STATE OF HAWAII
DEPARTMENT OF TRANSPORTATION
HIGHWAYS DIVISION

PROJECT NO. I-H2-1(13):4

MILILANI INTERCHANGE

SPRINKLER PLAN

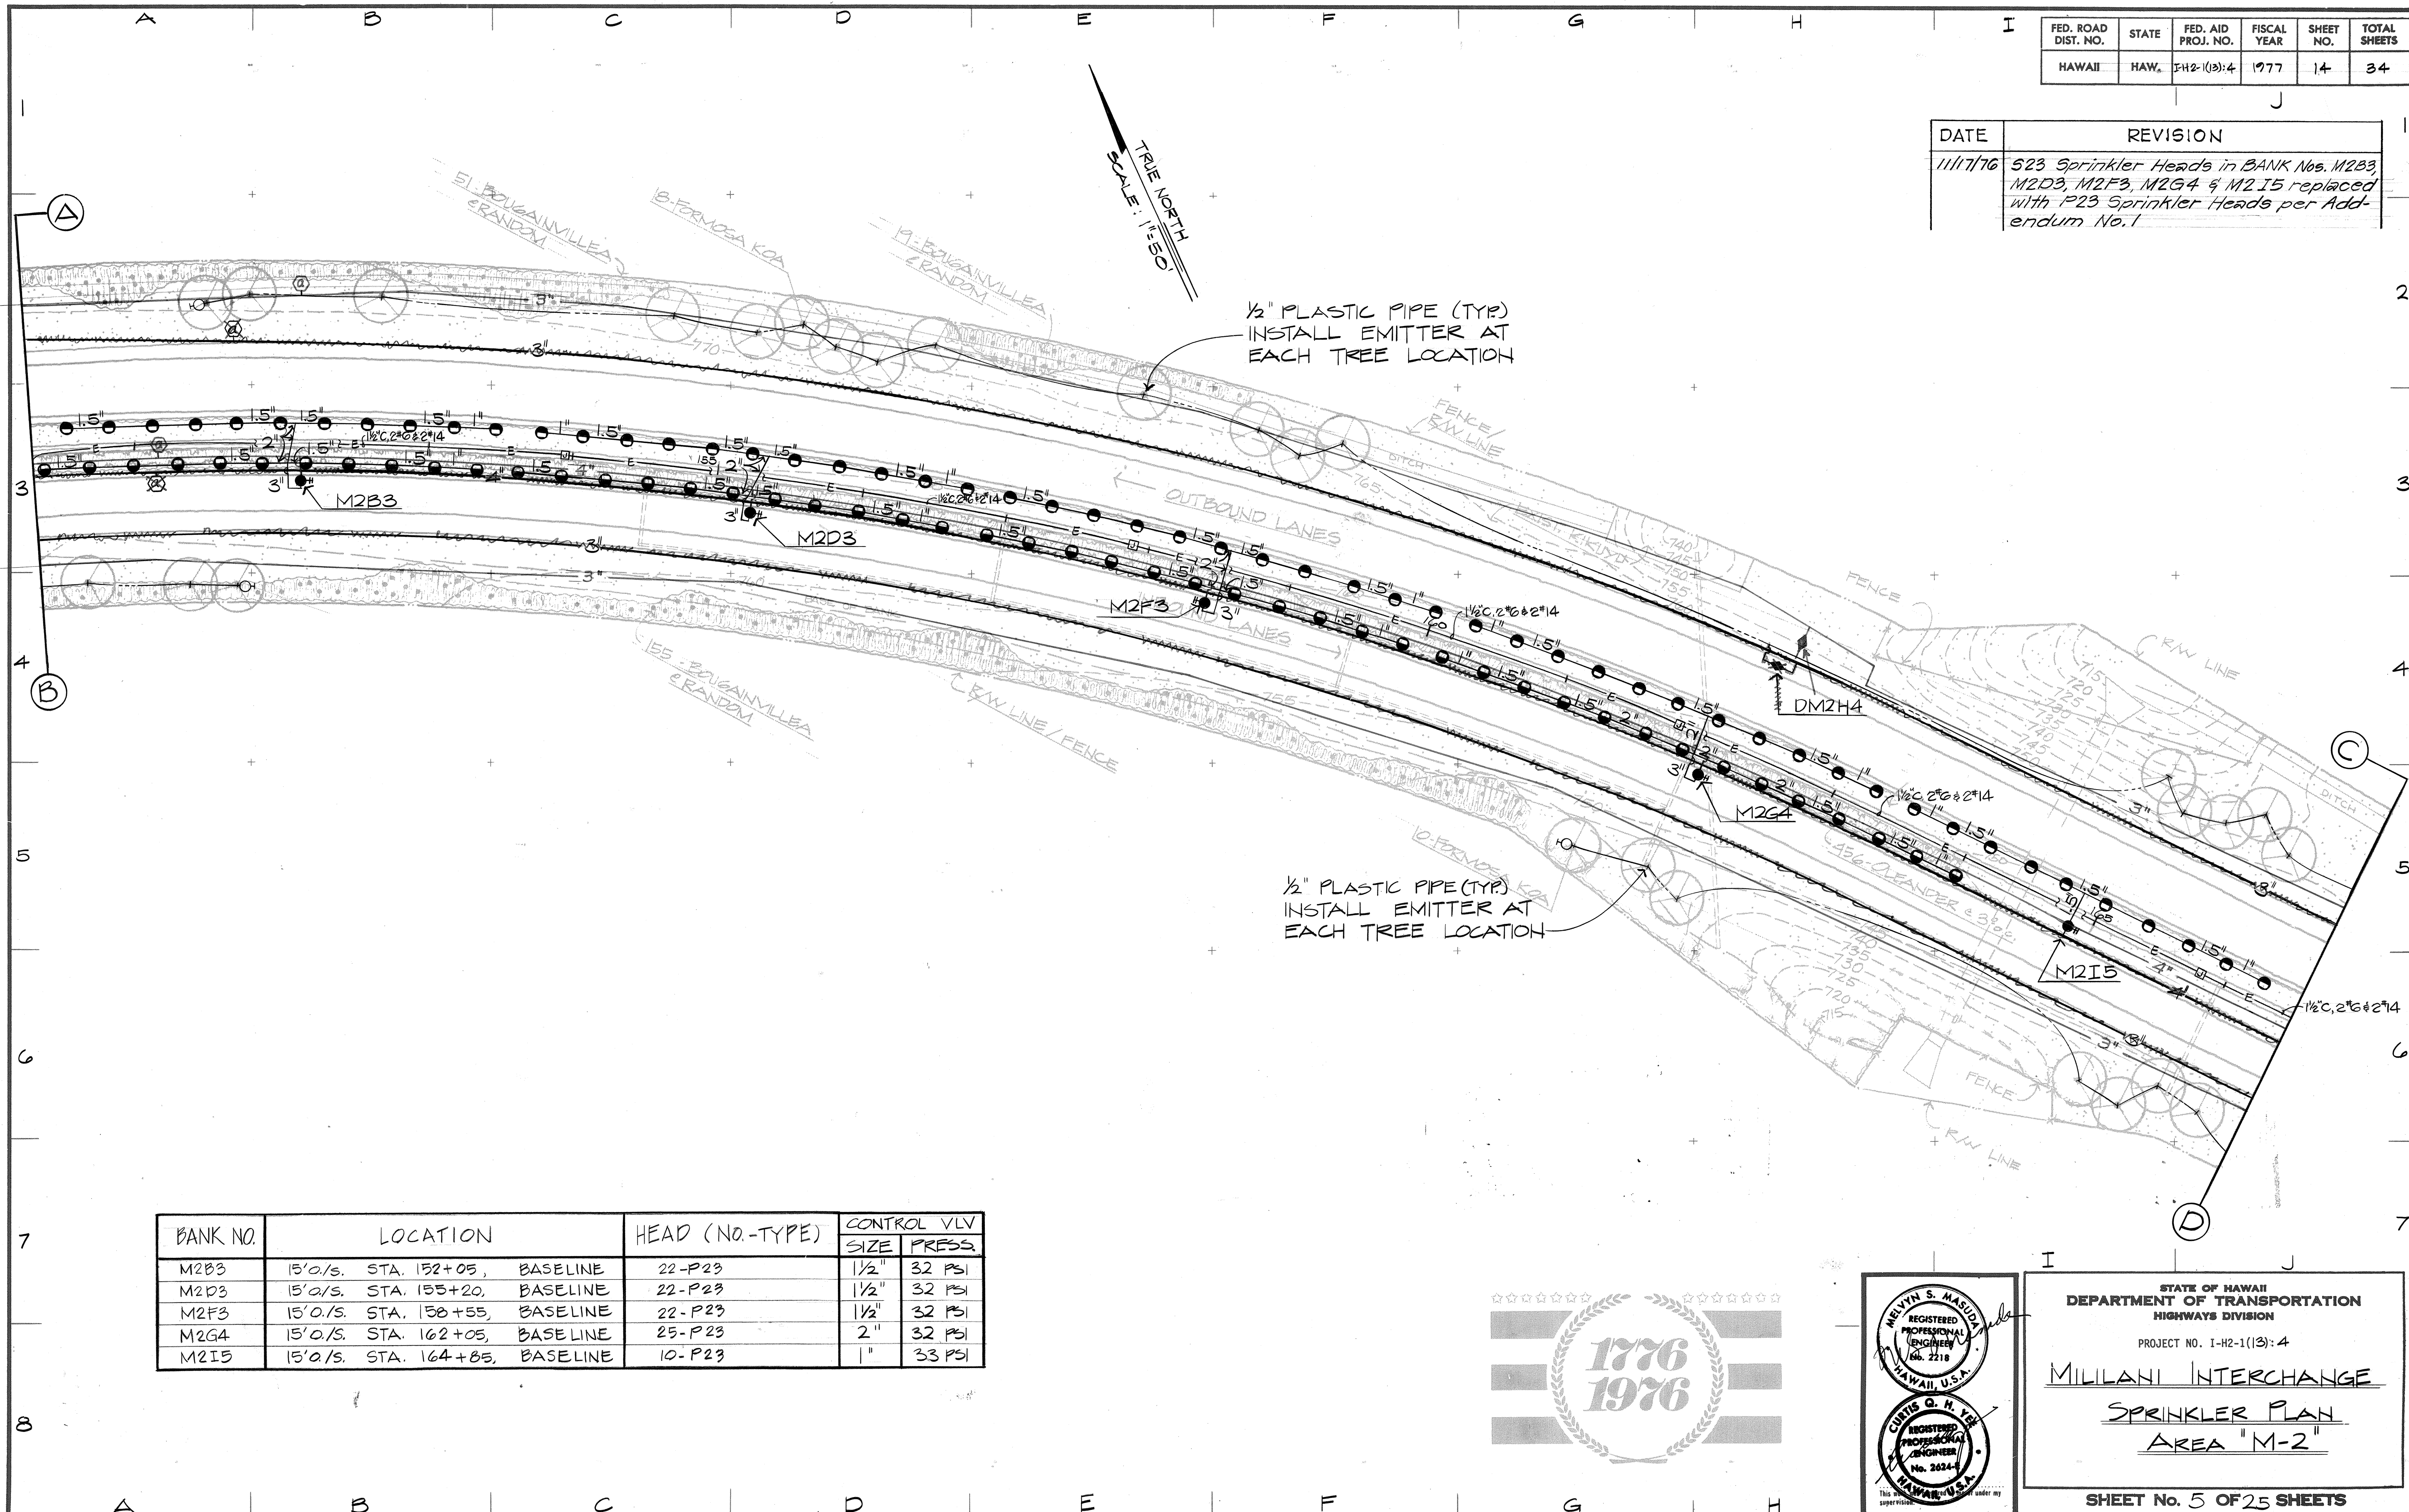
DATE	REVISION
11/17/76	523 Sprinkler Heads in BANK Nos. M2B3, M2D3, M2F3, M2G4 & M2I5 replaced with P23 Sprinkler Heads per Addendum No. 1

SPRINKLER PLAN

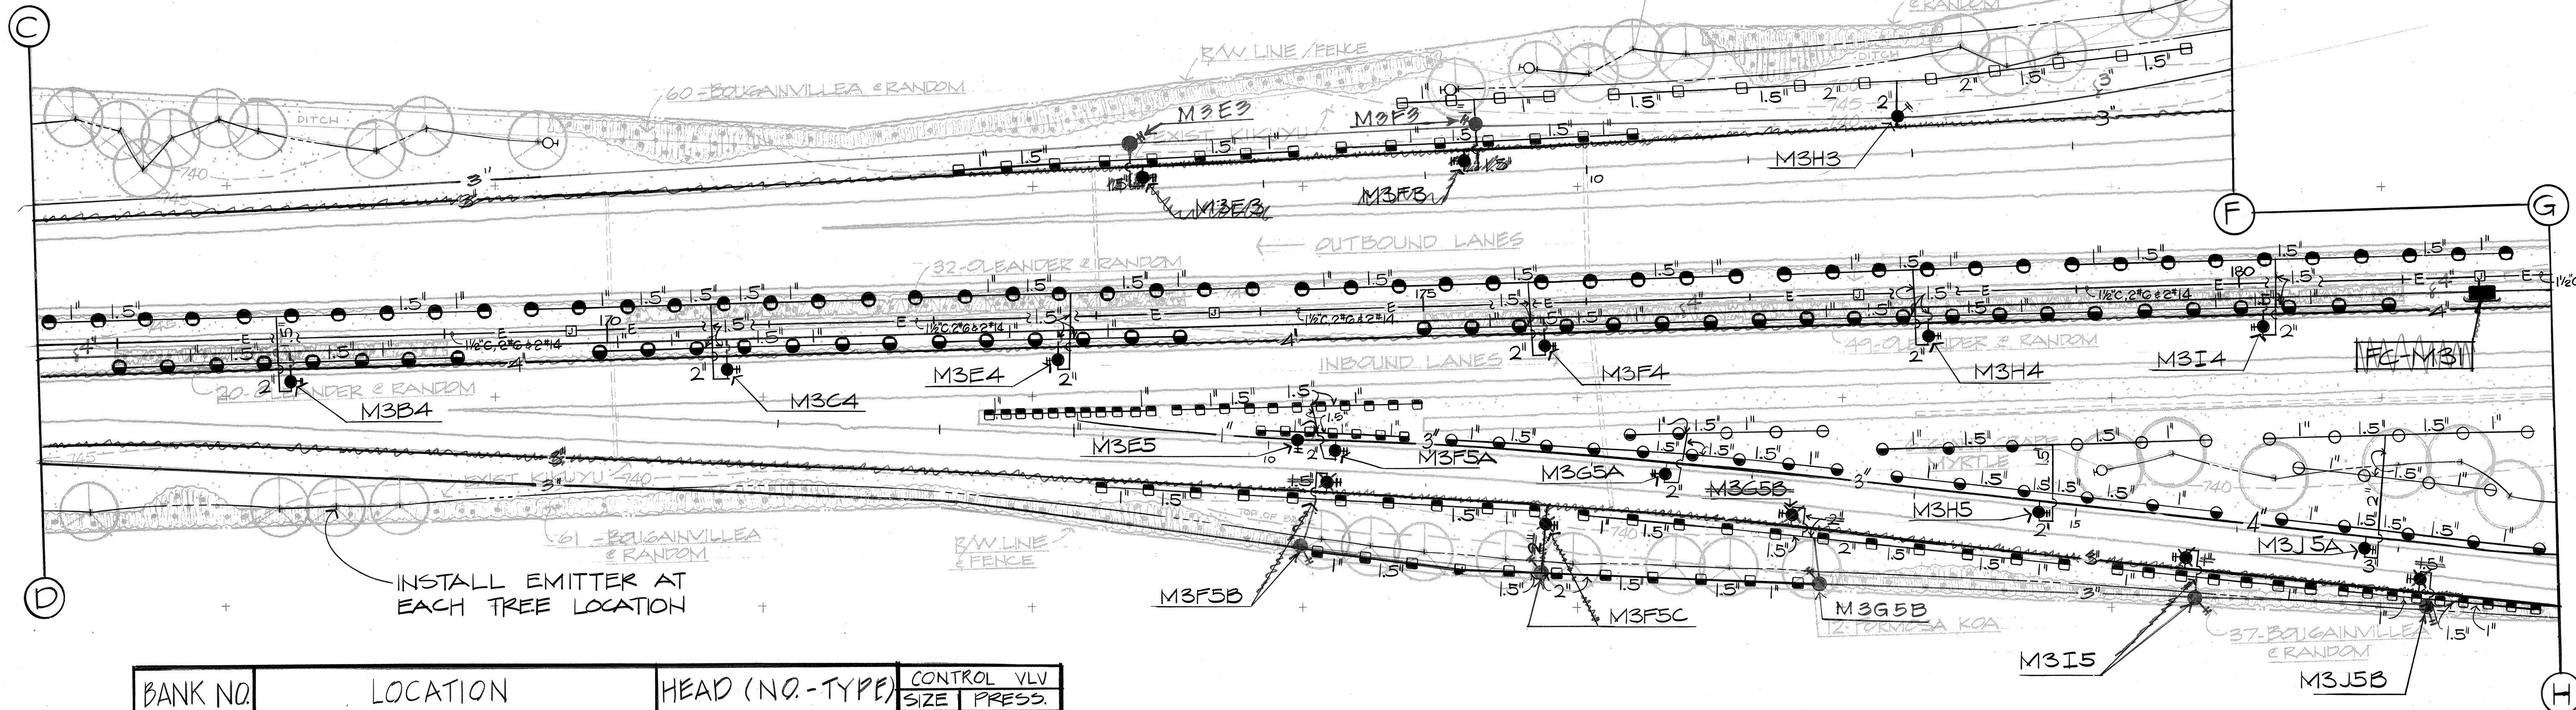
DATE	REVISION
11/17/76	523 Sprinkler Heads in BANK Nos. M3B4, M3C4, M3E4, M3F4, M3H4 & M3I4 replaced with P23 Sprinkler Heads per Addendum No.1

STATE OF HAWAII
DEPARTMENT OF TRANSPORTATION
HIGHWAYS DIVISION
PROJECT NO. I-H2-1(13)-4
MILILANI INTERCHANGE
SPRINKLER PLAN
AREA "M-5"
SHEET No. 8 OF 25 SHEETS

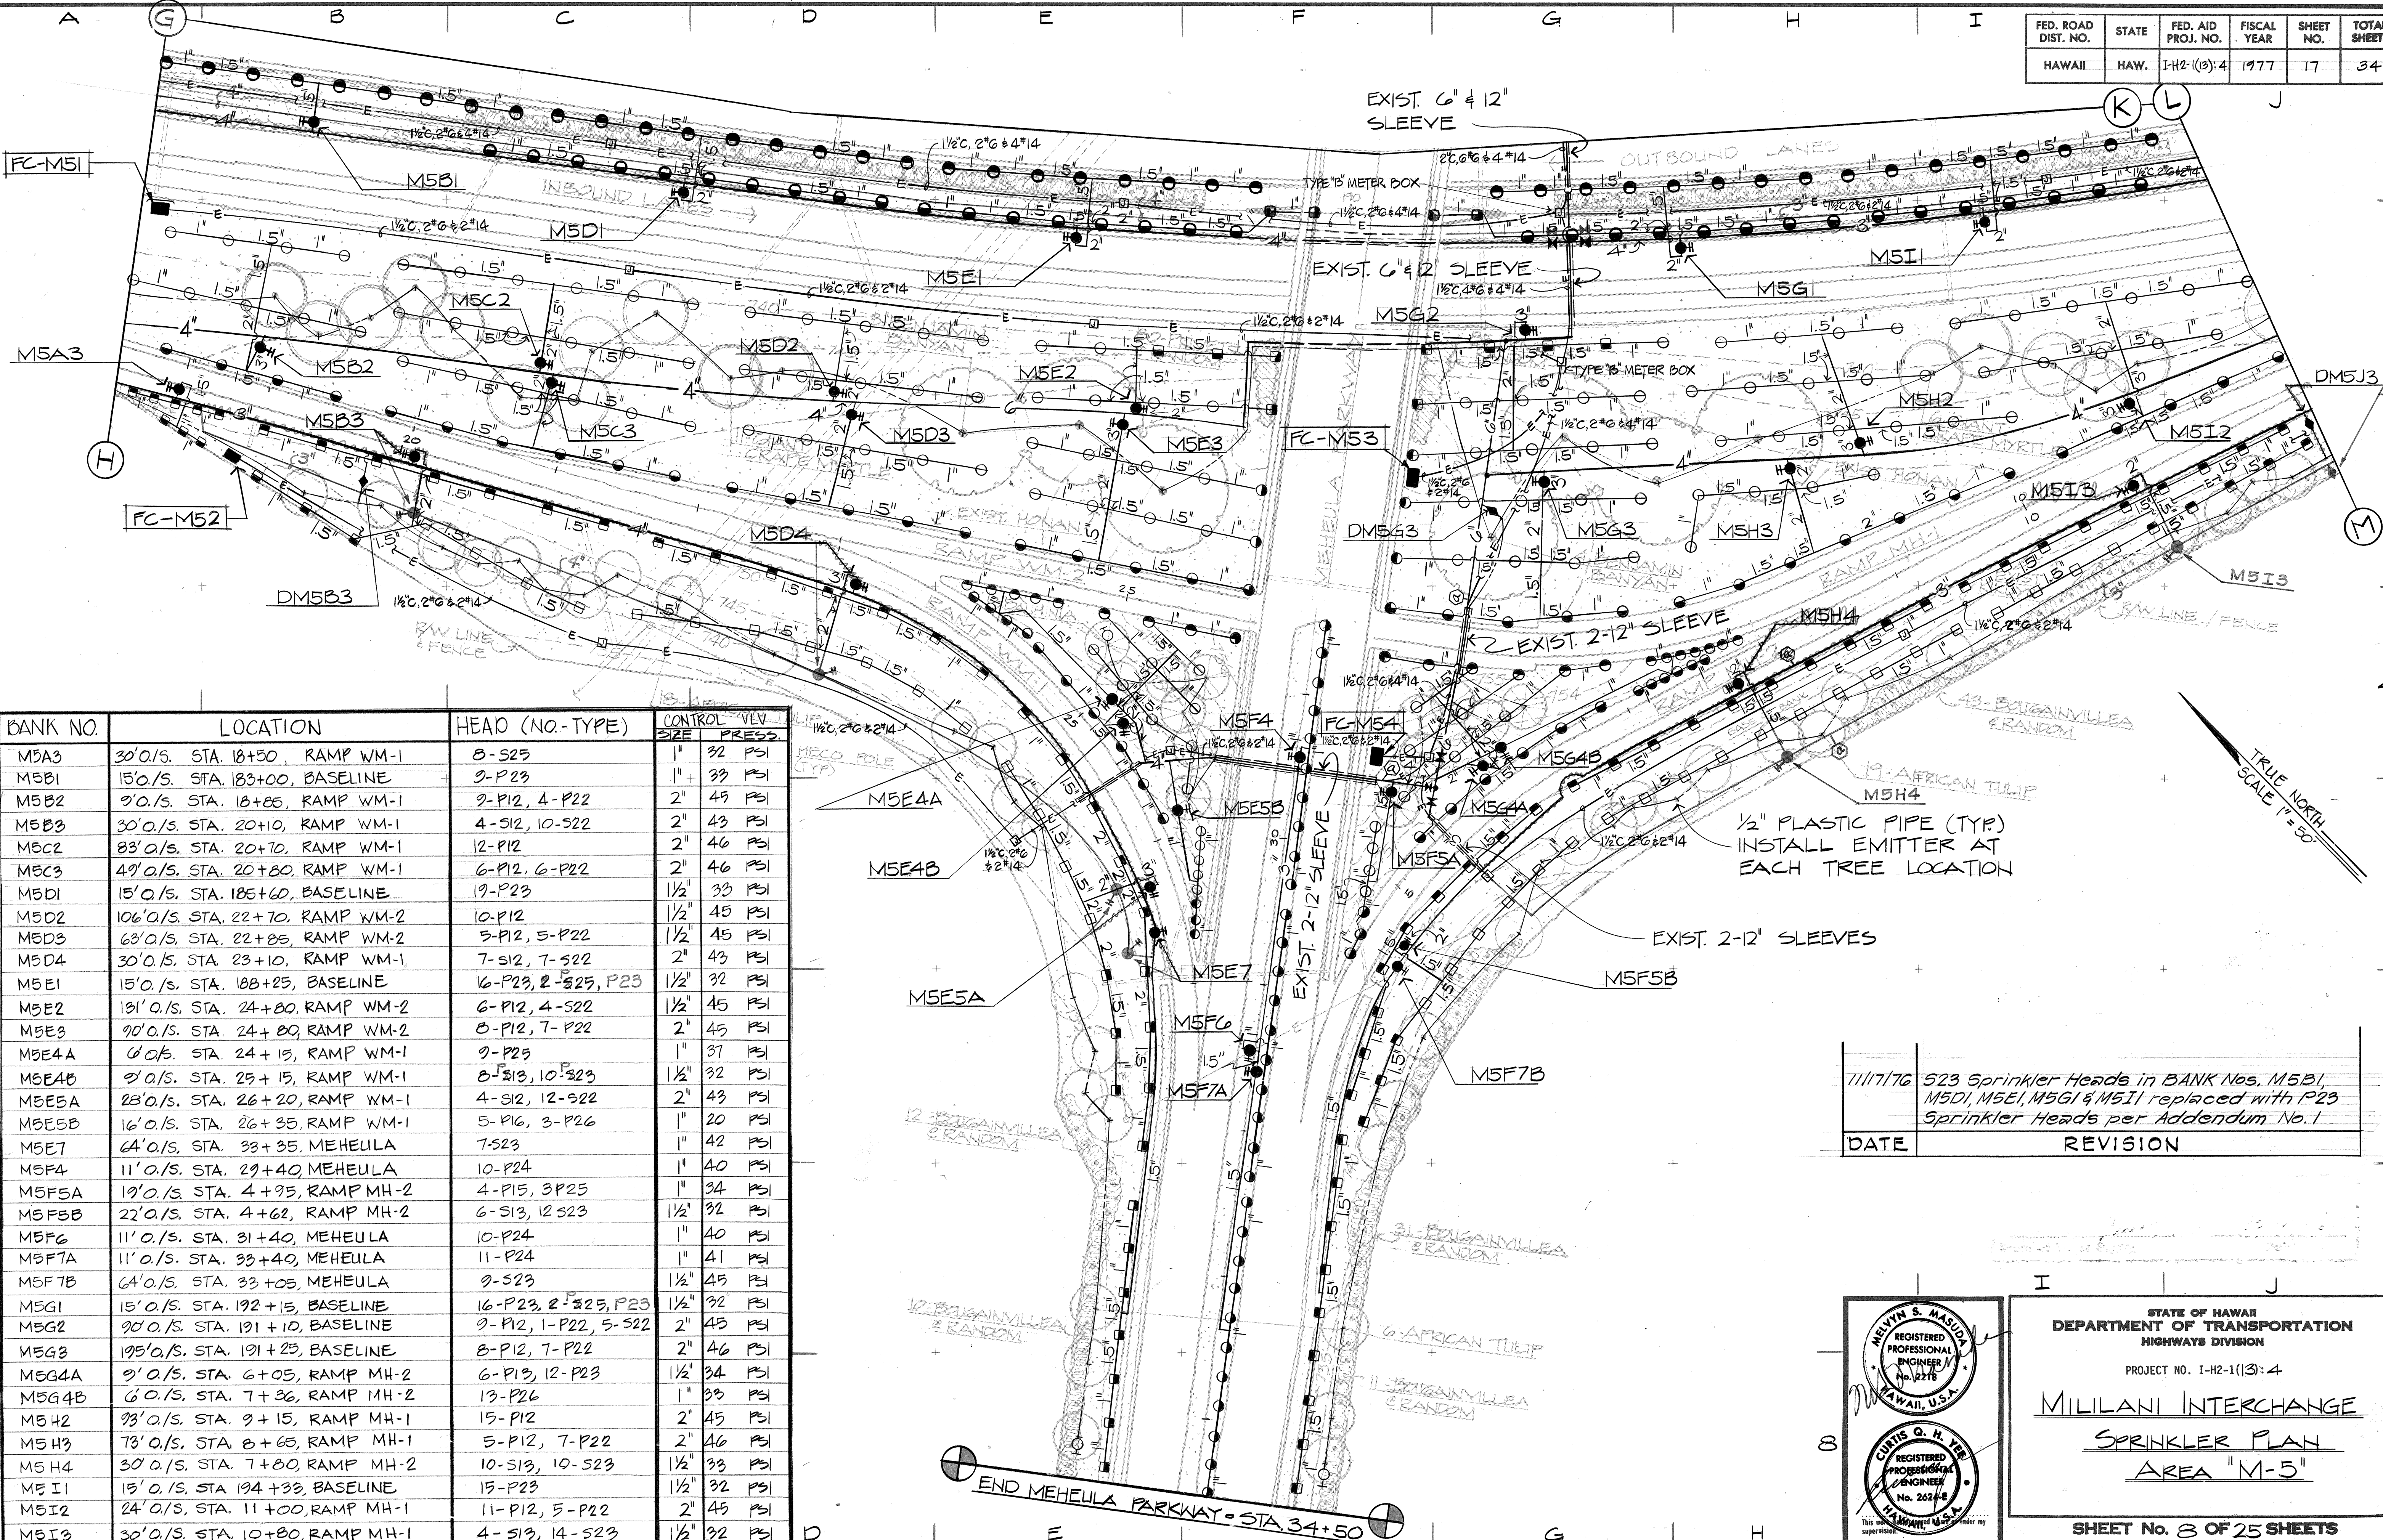
11/17/76	S23 Sprinkler Heads in BANK Nos. M5B1, M5D1, M5E1, M5G1 & M5I1 replaced with P23 Sprinkler Heads per Addendum No. 1
DATE	REVISION
